COLLISION REPAIR INFORMATION

TITLE: QUARTER PANEL SECTIONING
(CUT-P) PROCEDURE

SECTION: EXTERIOR BULLETIN #85

MODELS: ALL TOYOTA /LEXUS

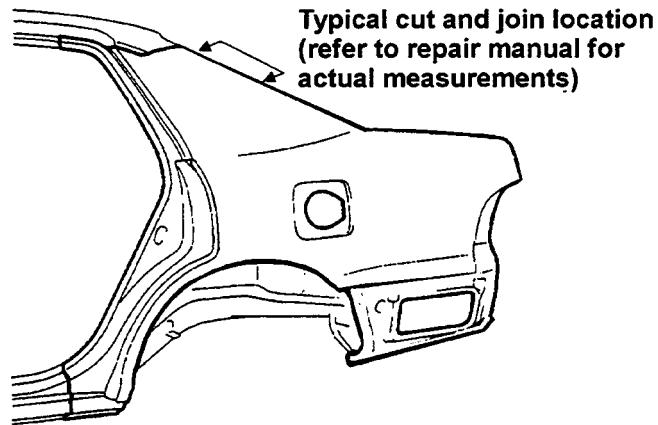
The Quarter Panel Sectioning (CUT-P) procedure, as shown in Toyota and Lexus Body Collision Damage Repair Manuals, and sometimes referred to as “vertical cut” is **no longer an approved** repair procedure (when replacing a damaged quarter panel) of any Toyota or Lexus vehicle. (see illustration below)

Toyota no longer approves of this CUT-P procedure for some of the following reasons:

- Visible cut and join locations from inner trunk compartment
- Body character lines are difficult to weld across
- Very difficult to perform an undetectable repair
- Customers overall cost of ownership is not reduced

The appropriate removal and installation specification for Quarter Panel sectioning are illustrated in each model-specific Repair Manual for Collision Damage, Body Panel Replacement section-Quarter Panel (CUT) procedure. The graphic below illustrates the typical cut and join location.

Always refer to the Toyota/Lexus model-specific repair manual for the actual cut/join location measurements, welding requirements and other important information.
